Comments on 9th Feb Draft

Dick Ferris 31/3/00

Figure 3 VSI TVG has acquired a control circuit:

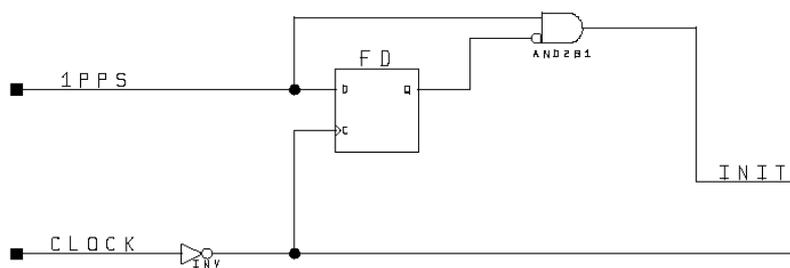
Since 1PPS is by definition already synchronous with CLOCK, the introduction of an inverter into the clock line as shown creates a timing race. While the intention is clear this is not appropriate for an engineering standard!

Given that in a real design both formatting the 1PPS/INIT pulse, and generating correctly phased bit-streams and CLOCK, will most likely happen elsewhere it is preferable to just stick to defining the logical process of generating the PRNs. e.g. Return to showing the sequence generator controlled by RESET (1Hz) and CK plus a supporting waveform diagram in the manner of the original CRESTech drawing. The design engineer can then incorporate this function and resolve the relationships with VSI specific waveforms in an appropriate manner.
